# UNITED STATES PATENT AND TRADEMARK OFFICE

APPLICATION NO.	FILING DATE	FIRST NAMED INVENTOR	ATTORNEY DOCKET NO.	CONFIRMATION NO.
10/723,502	11/26/2003	Benjamin Charles Nuttall	C-2725	8956

# Office Action Summary

**Figure 1** below illustrate the fuel cell power system including the fuel cell unit and the energy recovery device and the injection means:

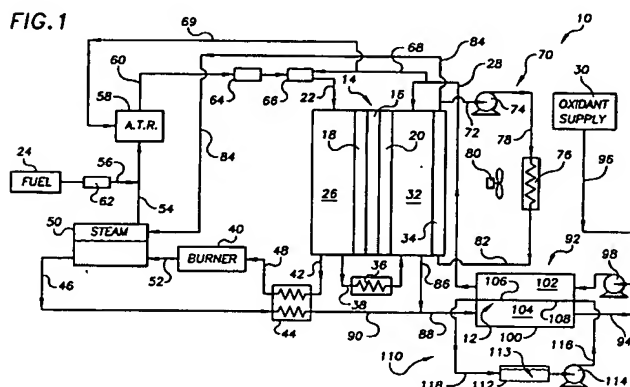
Grasso et al disclose a fuel cell power plant that generates electrical energy from a process oxidant stream and a reducing fluid stream comprising at least one fuel cell means for producing the electrical energy (CLAIM 1). Disclosed is the latent and sensible heat of the exhaust stream (COL 11, lines 50-55). Grasso et al also disclose a direct mass and heat transfer devices (*the energy recovery device*) secured in fluid communication with both a primary oxidant inlet line that directs the process oxidant stream into the fuel cell means and also with a plant exhaust passage that directs a plant exhaust stream out of the fuel cell means (CLAIM 1 /COL 7, line 55 to COL 8, line 50). The device includes a fine pore enthalpy exchange barrier in mass transfer relationship between the oxidant and exhaust streams passing through the device so that the process oxidant stream passes adjacent an inlet surface of the barrier and the plant exhaust stream passes adjacent an opposed exhaust surface of the barrier (CLAIM 1/ COL 7, line 55 to COL 8, line 50). Grasso et al inherently encompass the operation (*the method*) of the fuel cell plant using the energy recovery device (COL 11, lines 48-67/CLAIM 25).

Grasso et al further disclose that the mass and heat transfer device means may include a liquid transfer medium supply means for supplying a liquid transfer medium thereto (COL 8, lines 33-50). Disclosed is that transfer feed line 116 is in fluid communication between the reservoir 112 and the barrier 12 (COL 8, lines 33-50). Water may be the liquid transfer medium (COL 9, lines 52-60). *Thus, the examiner sets forth that Grasso et al's liquid transfer medium supply means serves as the claimed injection means disposed to inject a liquid medium thereinto.*

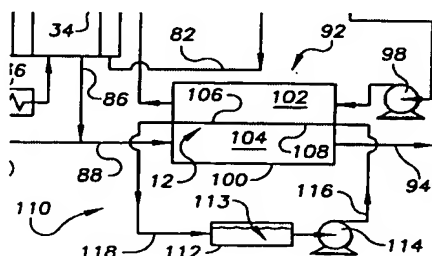
Concerning claims 2-3:

As evident from enlarged portion of Figure 1 below, the energy recovery device include the oxidant chamber 102 for receiving oxidant through inlet line between chamber 92 and blower 98; the transfer medium feed line 116 for introducing a liquid medium into chamber 102 and positioned immediately upstream of the inlet line (SEE Figure 1). Water may be the liquid transfer medium (COL 9, lines 52-60). *It is also contended that the inlet regions of both the oxidant the liquid transfer medium encompasses the plenum.*
